Title & Document Type: HP 339A Operating and Service Manual

Manual Part Number: 00339-90001

MODEL 339A

DISTORTION MEASUREMENT SET

Figure 8-17. Oscillator Circuits.
8-21/8-22

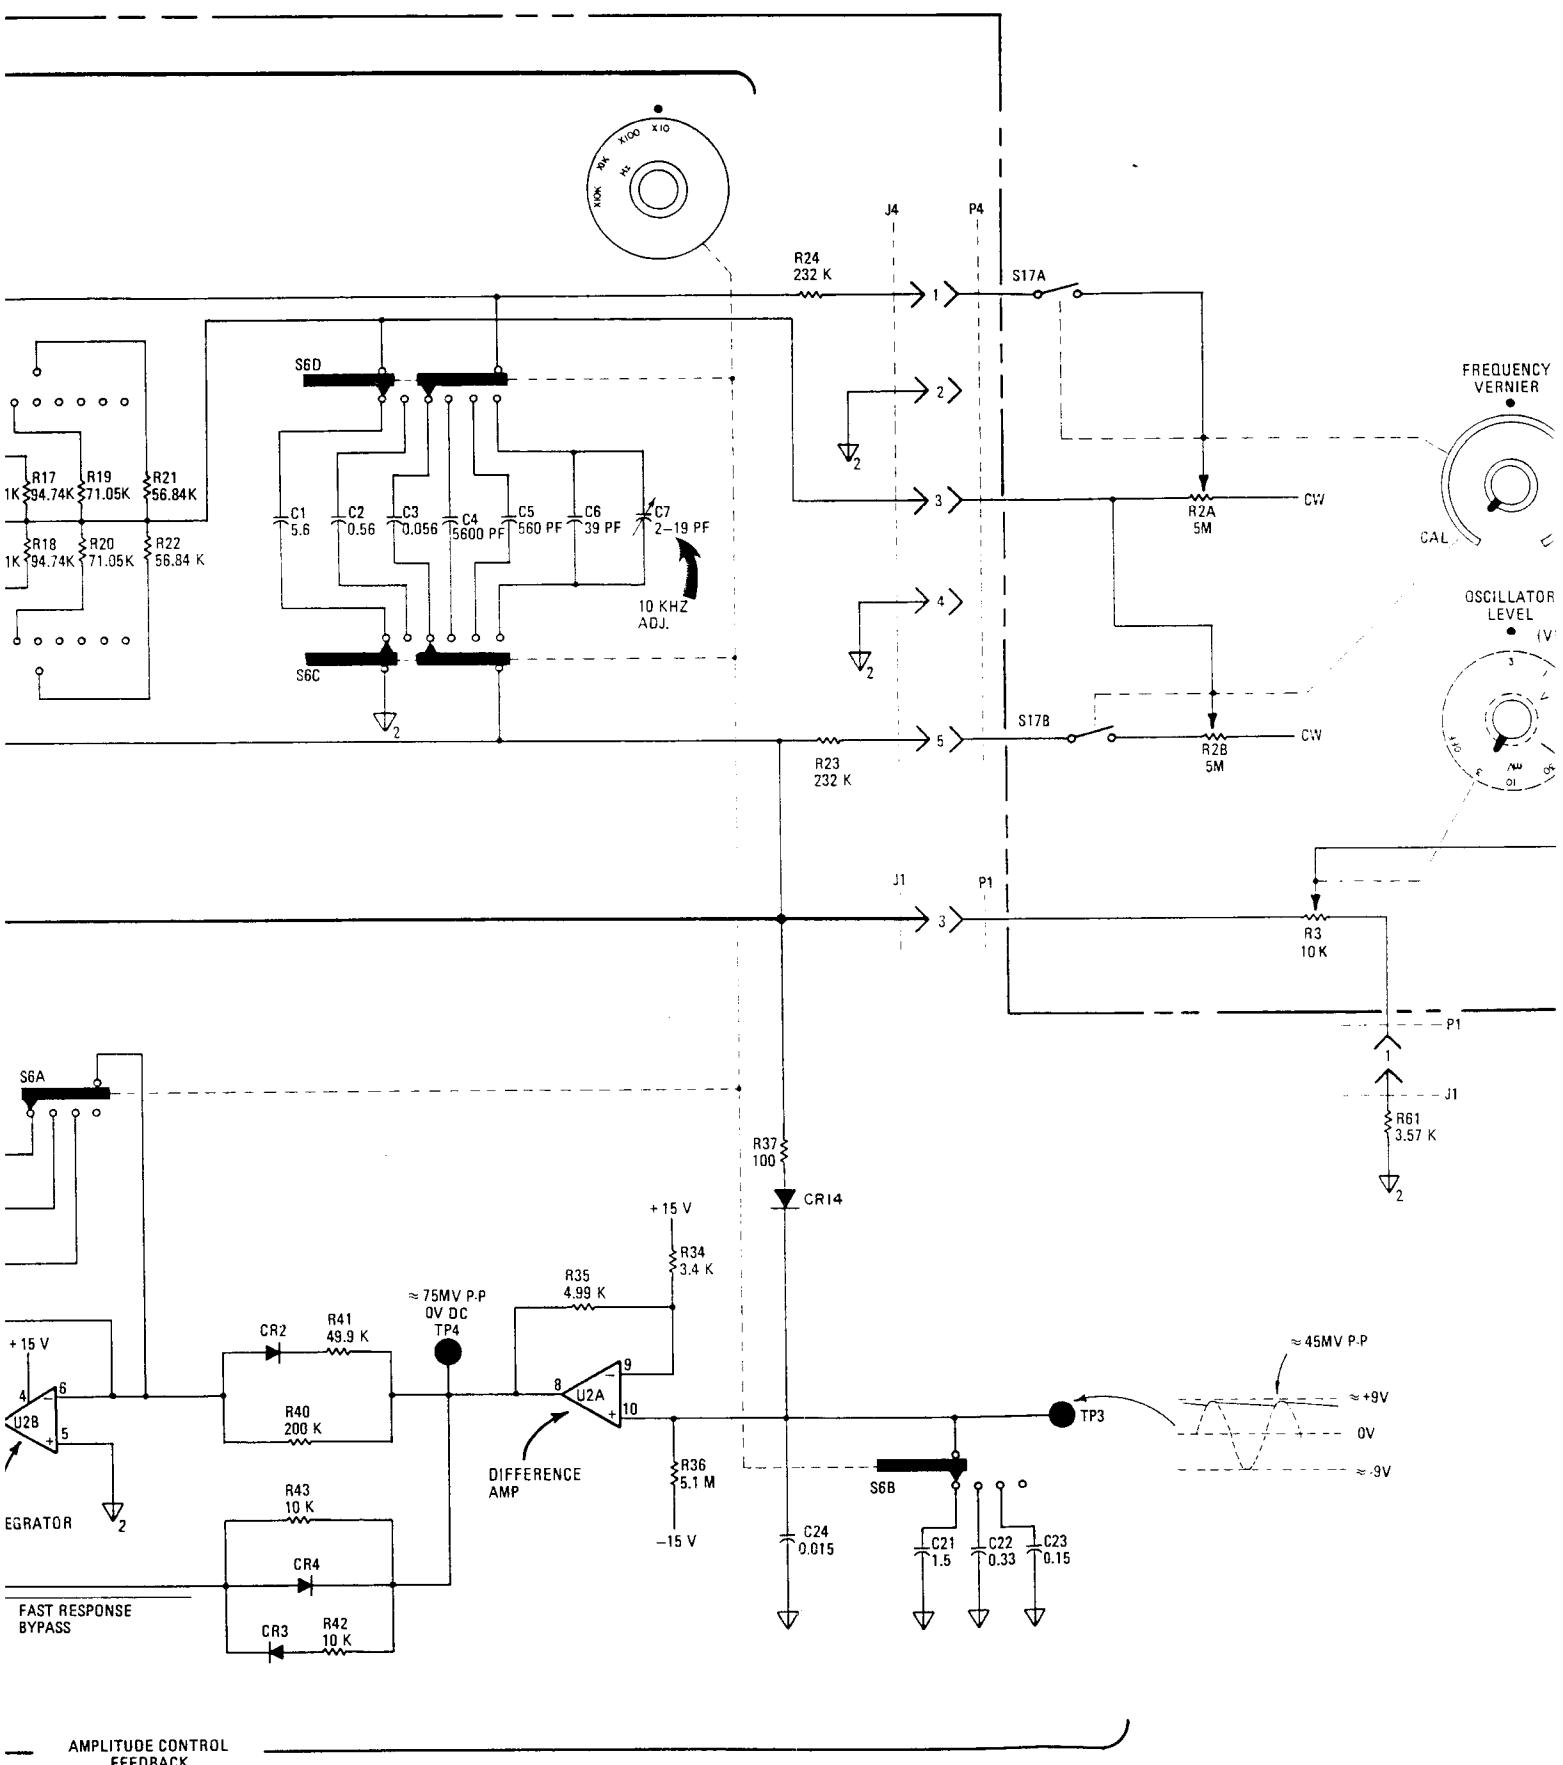
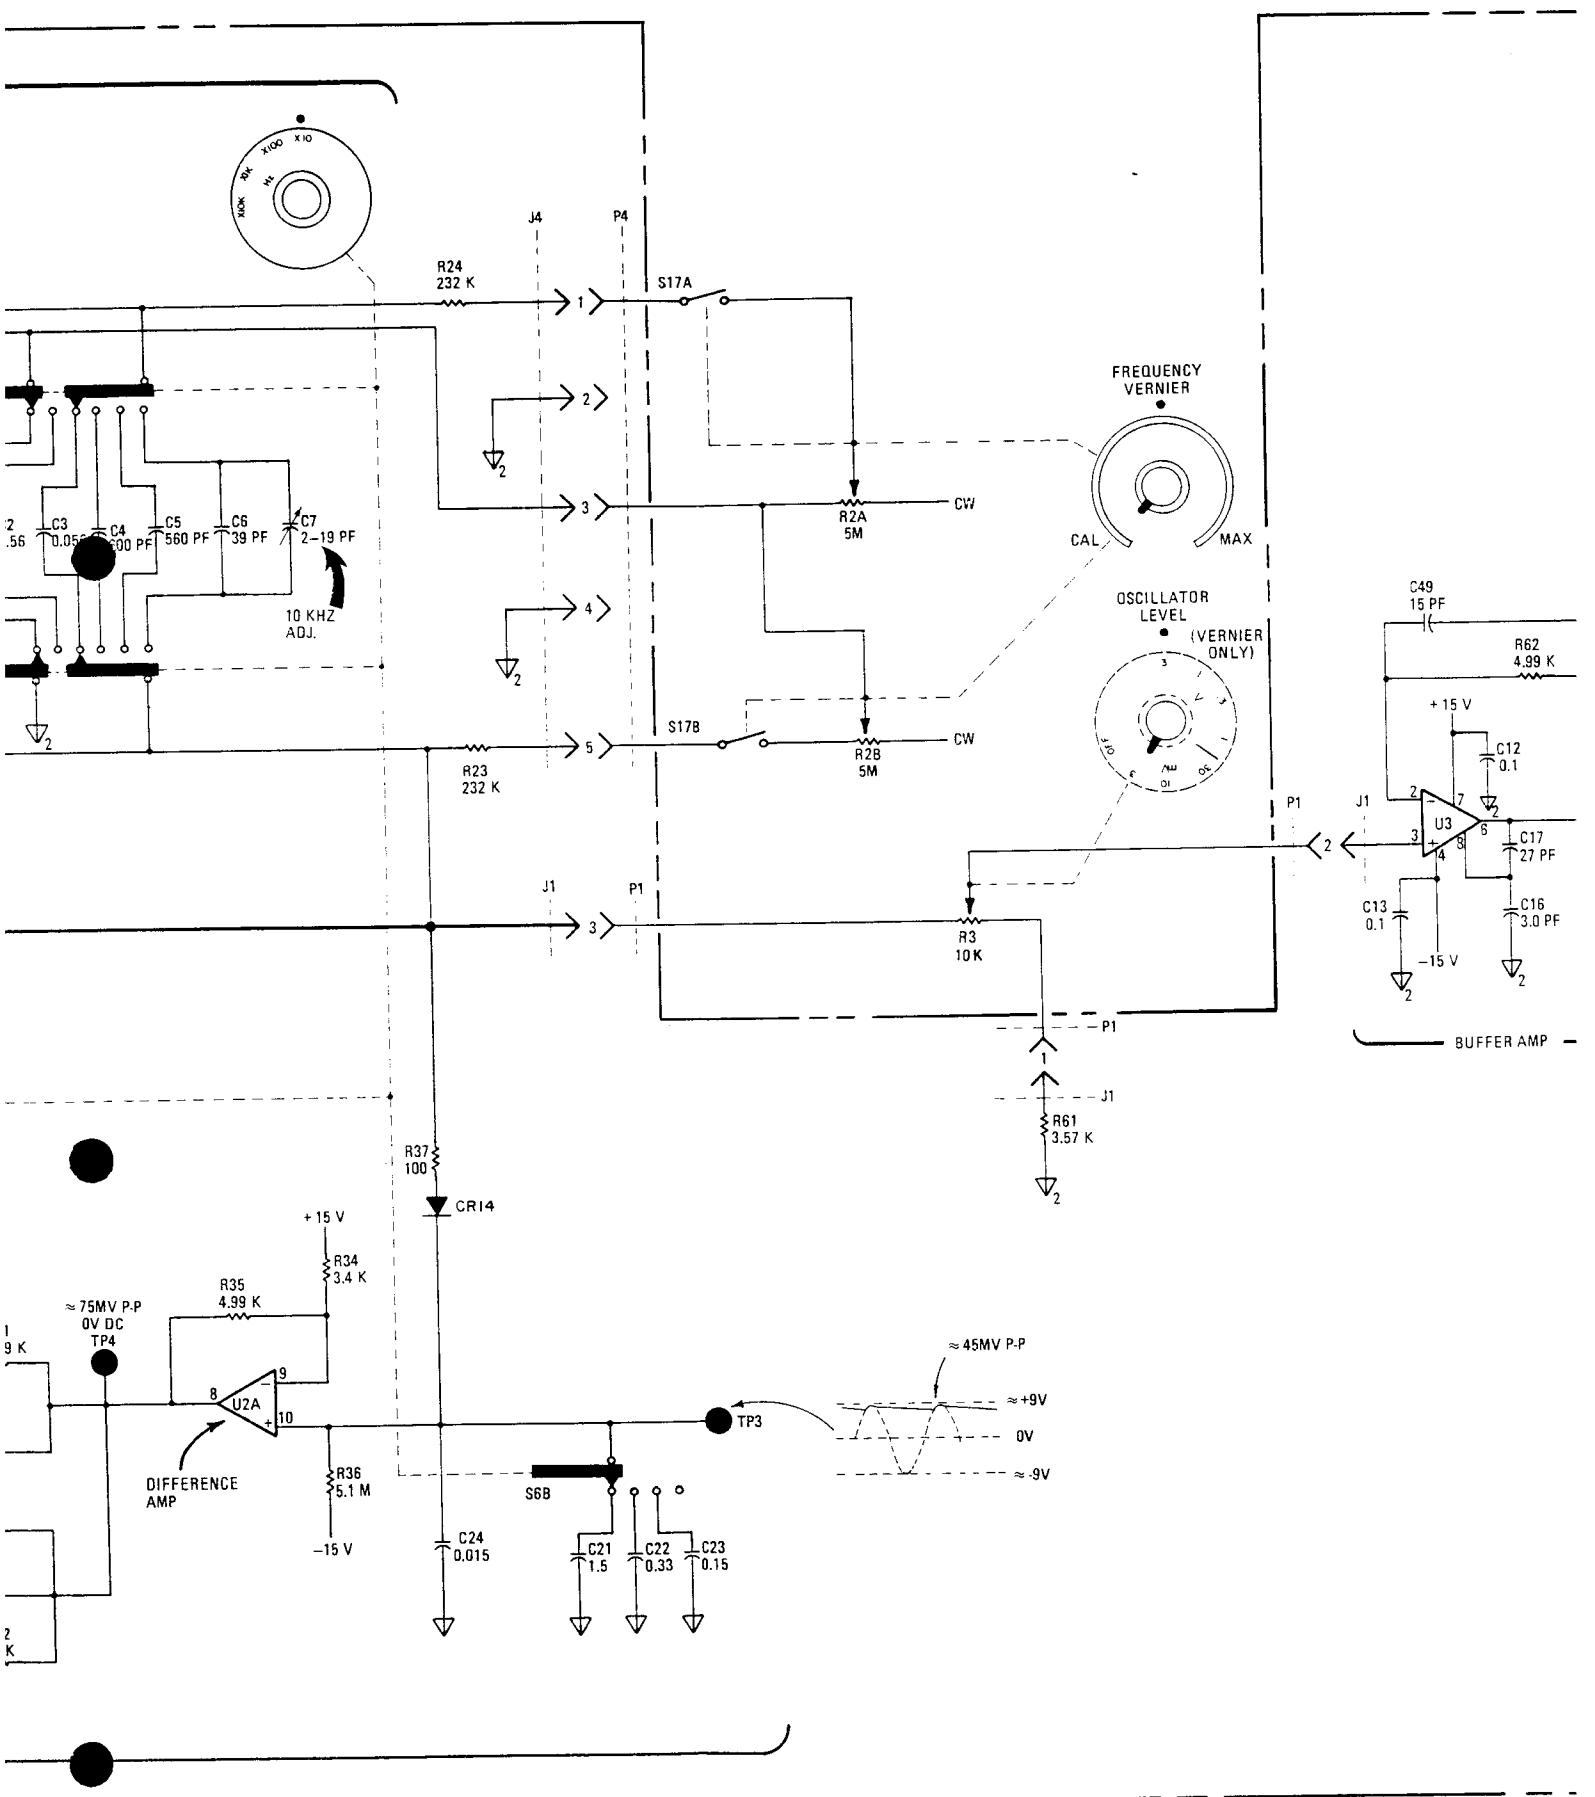
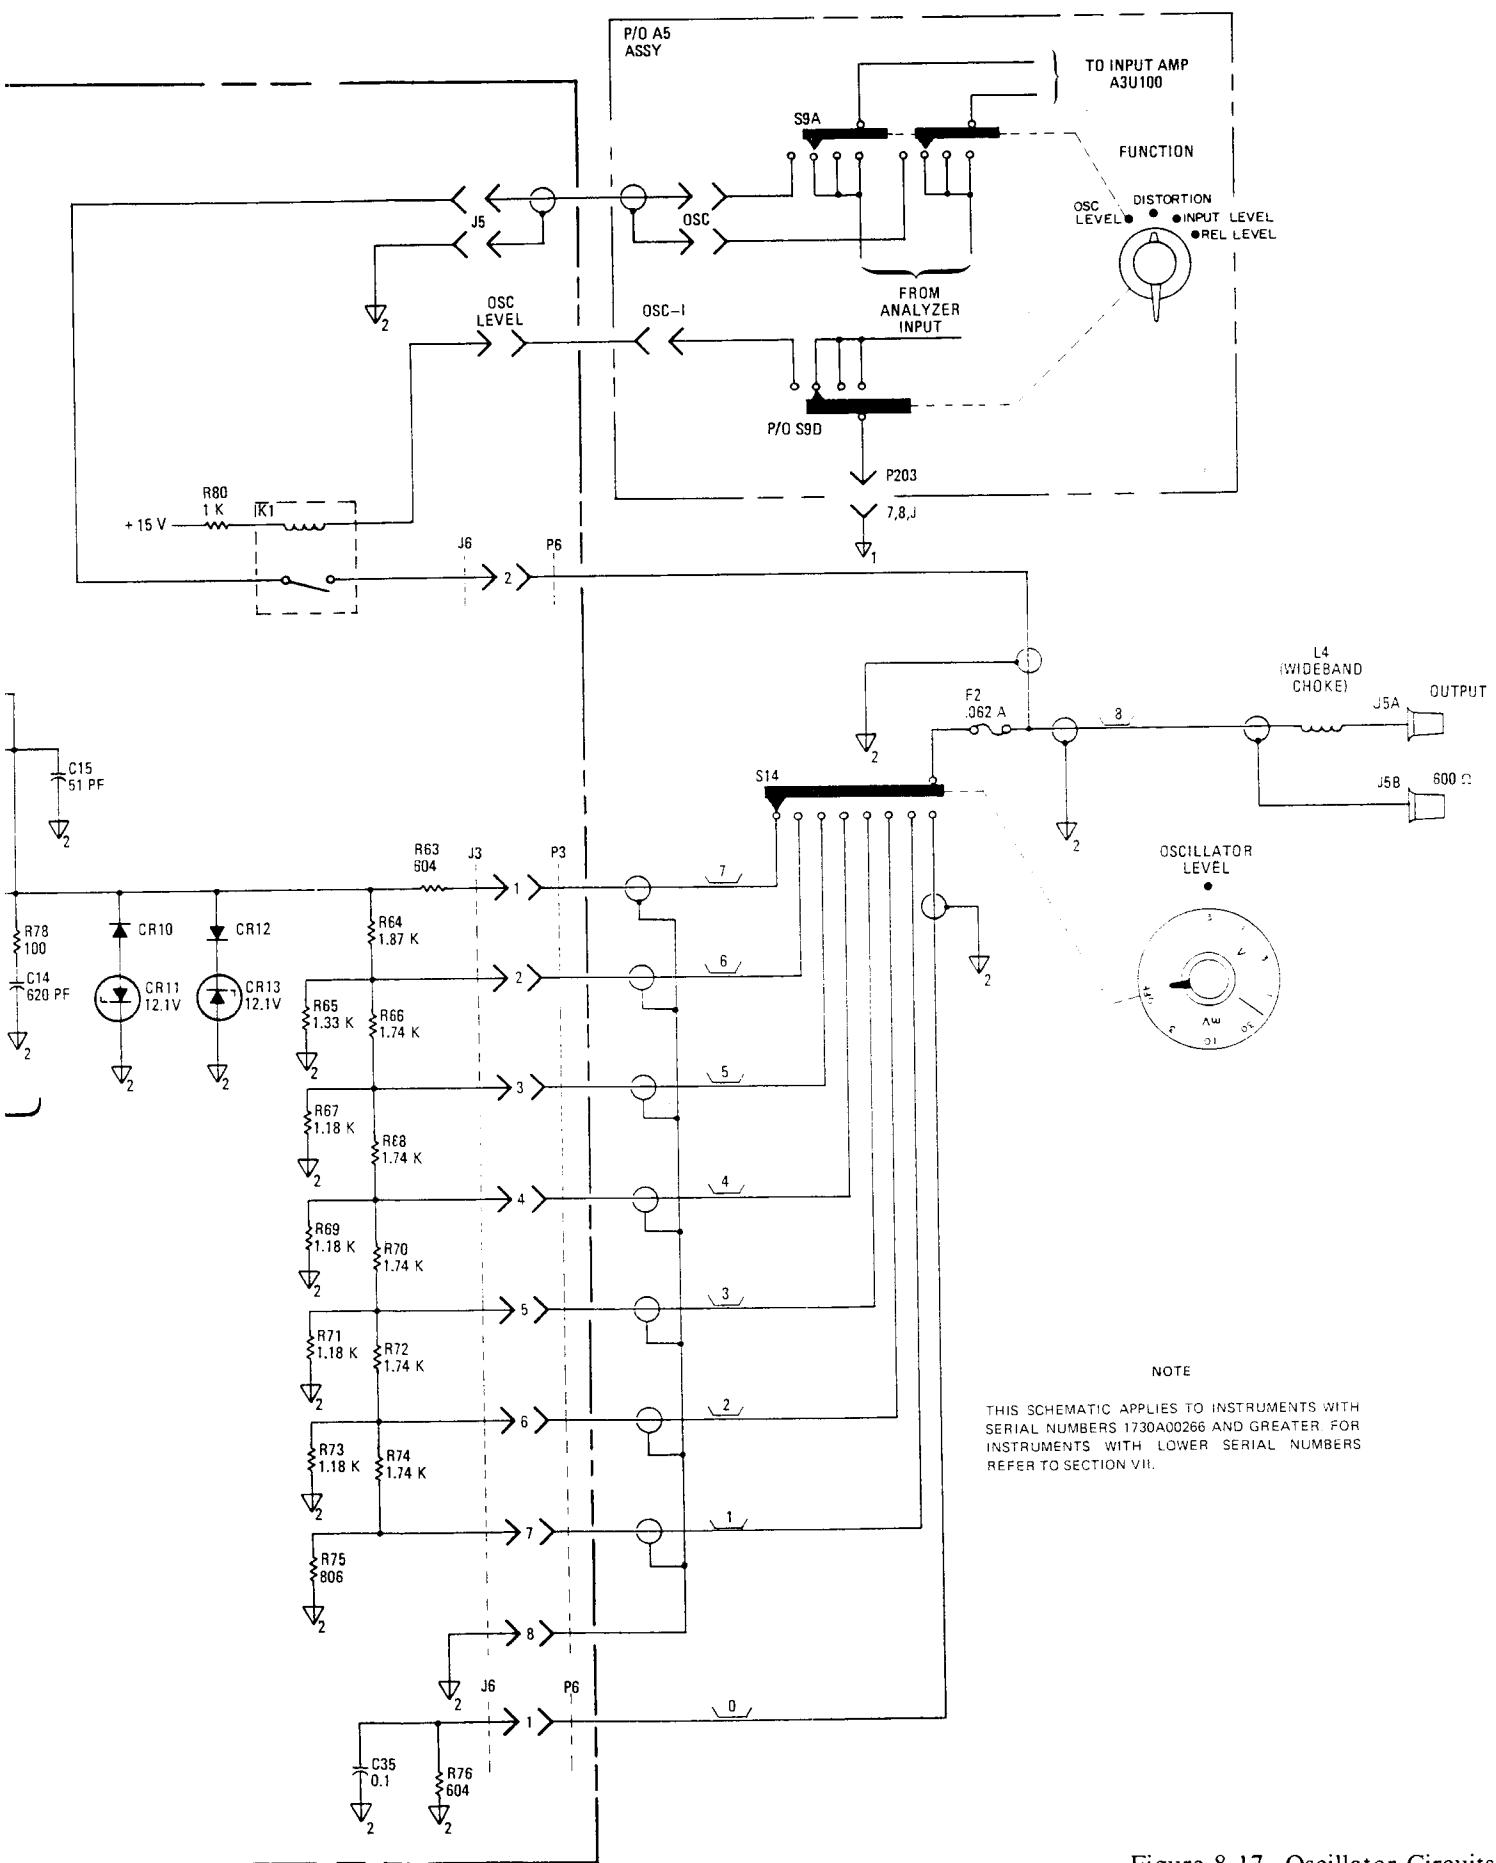
Page 8-21/8-22, Figure 8-17. Change the value listed on the schematic for C47* from 510pF to 200pF.

Page 8-21/8-22, Figure 8-17. Change the schematic value of C21 from 1.0uF to 2.2uF.

Figure 8-18. Power Suppli
8-23/8

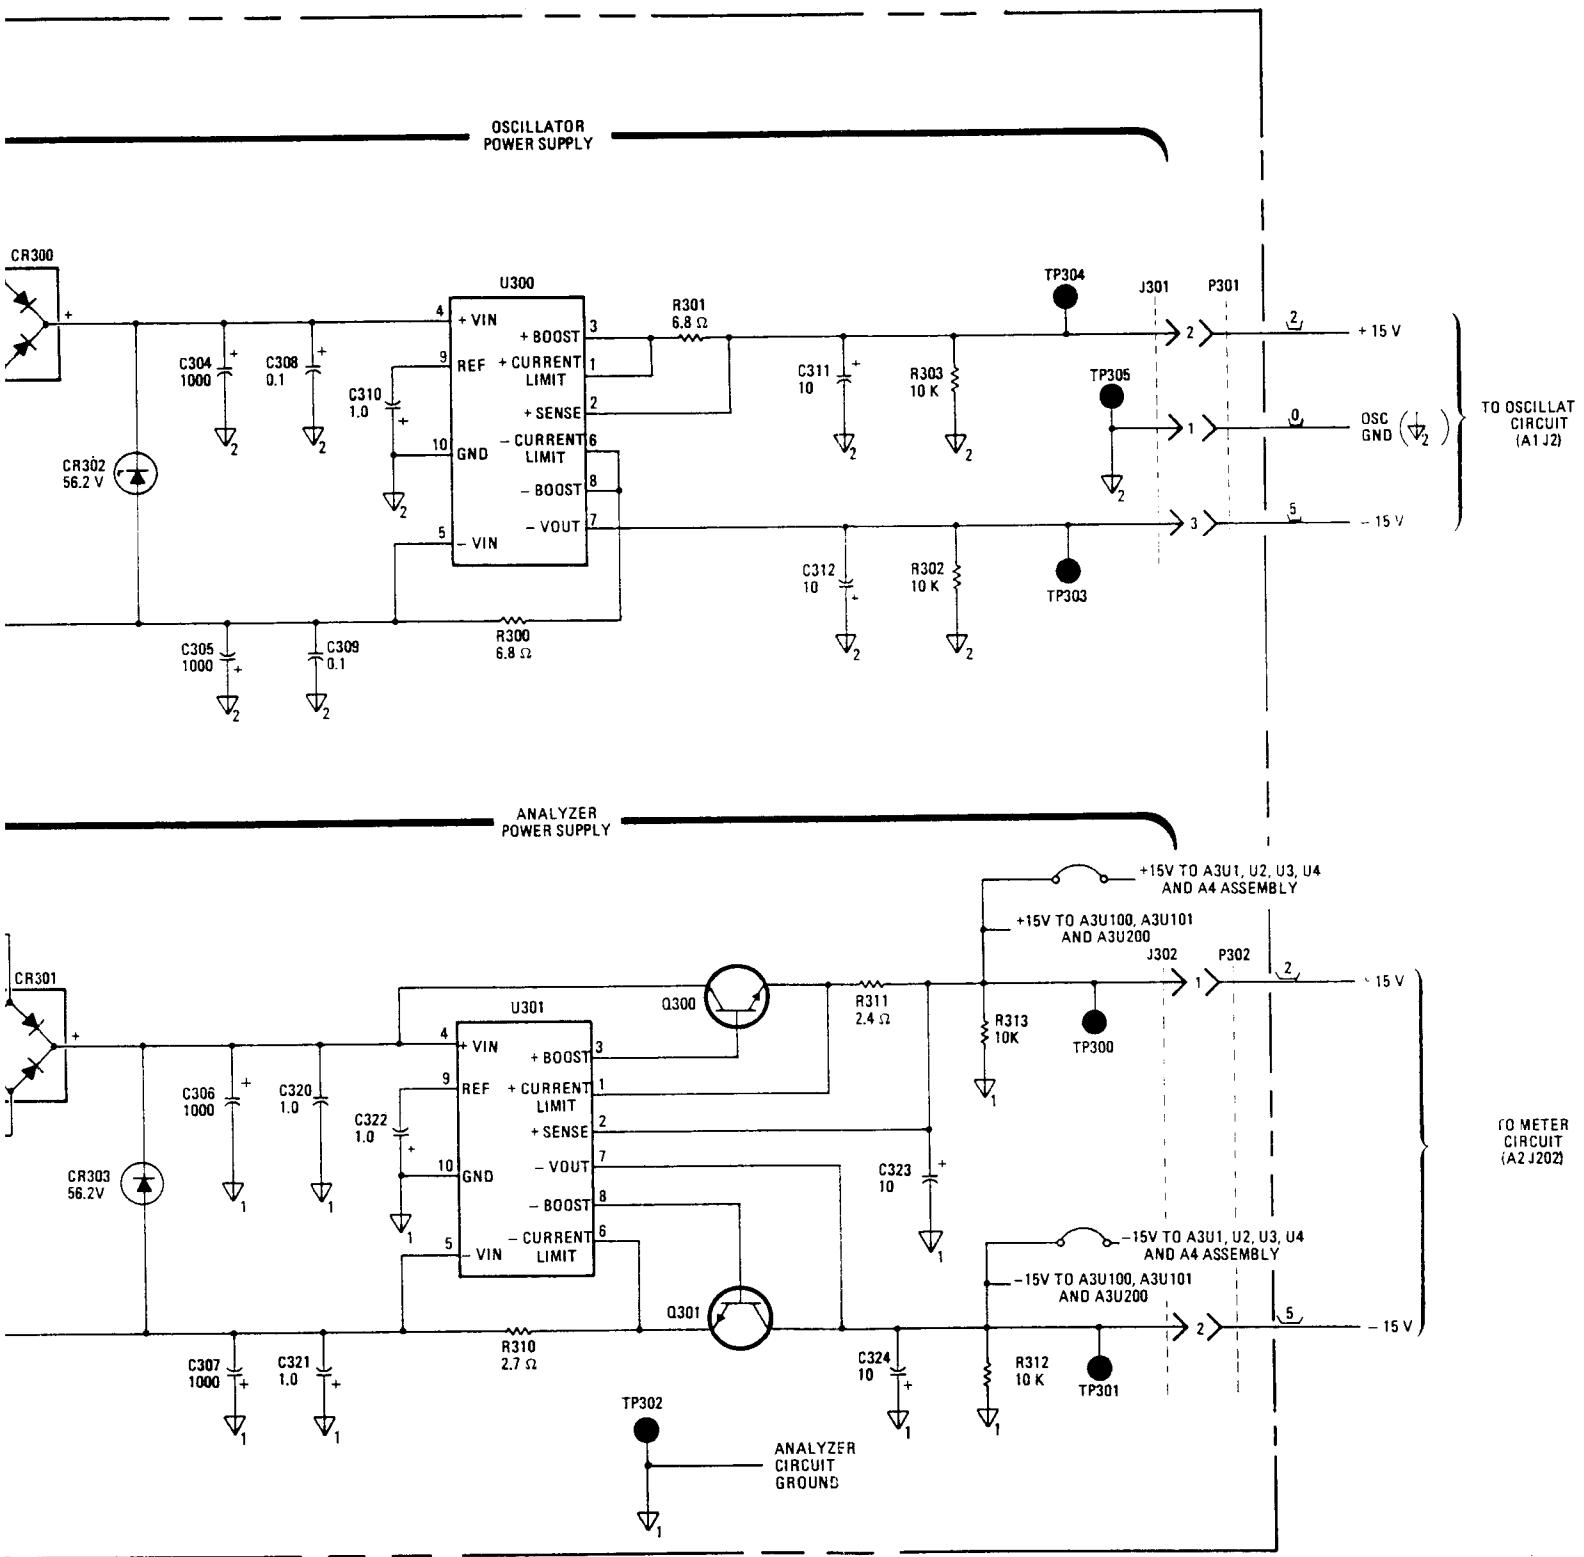
Page 8-23/8-24. Change the Power Supply schematic diagram as shown in Figure 3.

Page 8-23/8-24, Figure 8-18. Change the schematic value of C324 from 10uF to 15uF.

Figure 1.

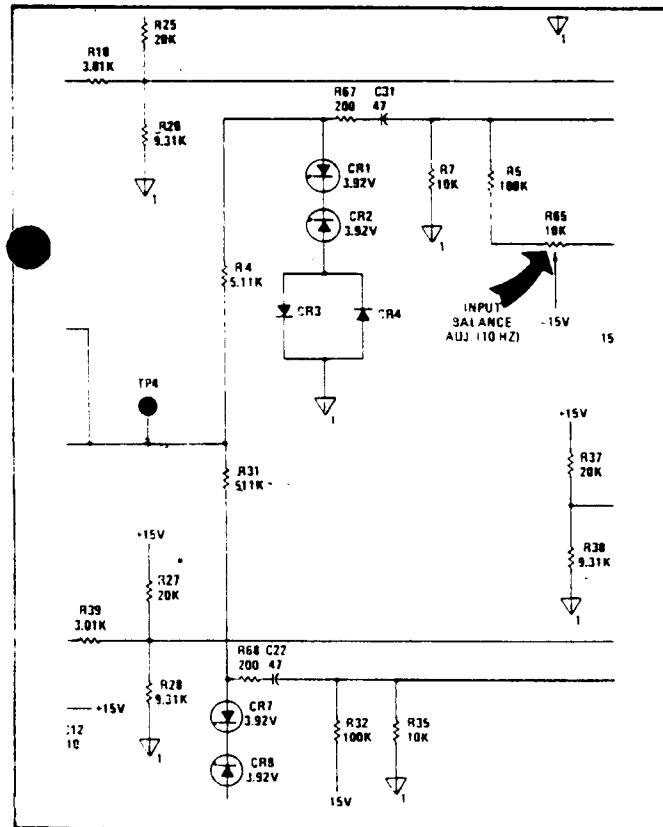
Page 8-17, Figure 8-15. Delete parts L3 and L4 from the schematic. Add resistors R67 and R68 as shown in Figure 1.

Resistor R67 and R68 have replaced L3 and L4 for the prevention of high frequency oscillation.
